SAFEGUARD PUMPS

ARIZONA NUCLEAR POWER PROJECT
UNITS 1, 2, 3, 4 AND 5

SPECIFICATION NO. 14273-PE-410, REV. 02

Nuclear Power Systems
COMBUSTION ENGINEERING, INC.
Windsor, Connecticut

Sketch 14273-1

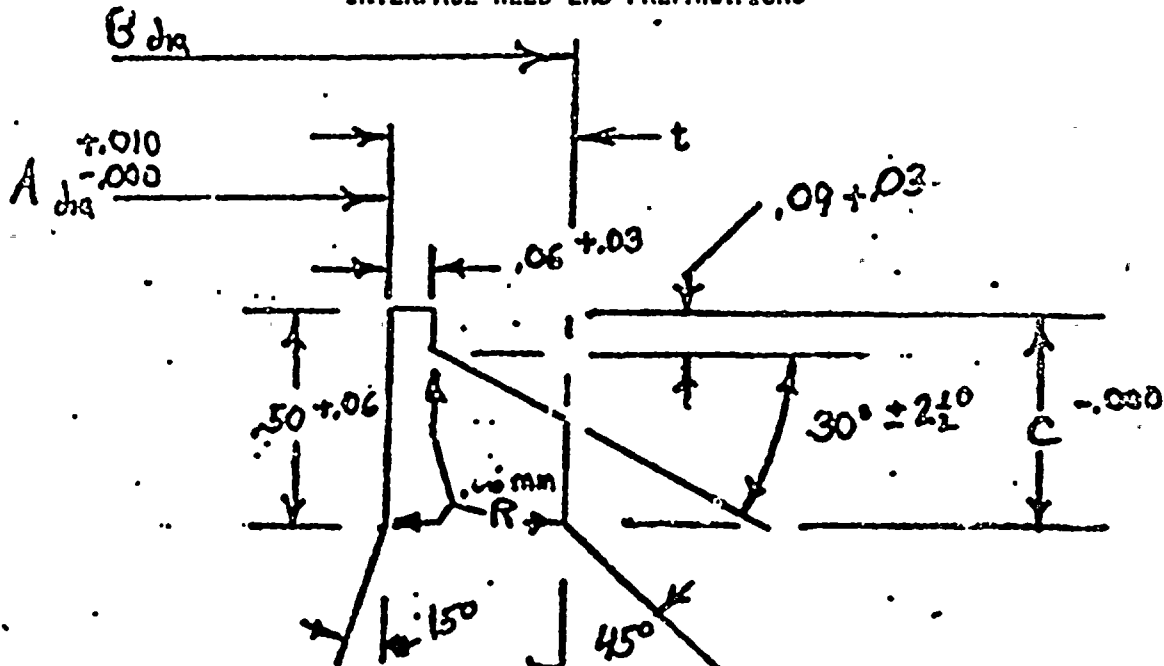
4.2.15 Delete: Data Sheet 26.16, Attachment 2. Substitute: Attachment 4.

9.1 Attachment 2, Delete and Substitute Attachment 4 (Weld End Props).

INTERFACE WELD END PREPARATIONS
